**SOLICITATION AMENDMENT
MODIFICATION DE
L'INVITATION**

Title - Sujet Cartridge Calibre .308 Winchester Ball Match 155 Grain	Amendment No. - N° modif. 003
Solicitation No. N° de l'invitation W8486-228294/B	Date of Amendment Date de modification 2022-07-26
Address enquiries to: - Adresser toute demande de renseignements à : Kaman Law, DLP 9-1-6	
Telephone No. - N° de telephone 343-553-4368	E-Mail Address - Courriel Kaman.Law@forces.gc.ca
Destination See herein - Voir aux présentes

1. Answer questions submitted by bidders; and,
2. Modify the Request for Proposal.

Fig 2. Example of a diagram of packaging

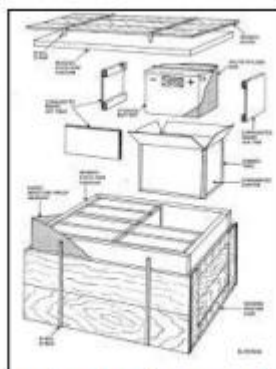
Question 3: As you can see in the photo below, I am trying to get a clear visual of the precise packaging requirements. If possible, can I acquire a clear larger copy of the requirements.

Answer 3: These pictures of packaging drawings are included in the SOW as examples only, as the type of diagram or engineering drawing that DND requires for CFTO purposes. So to be clear, these pictures are not specific packaging requirements for the cartridge, but only examples of the type of technical documentation that DND will require.
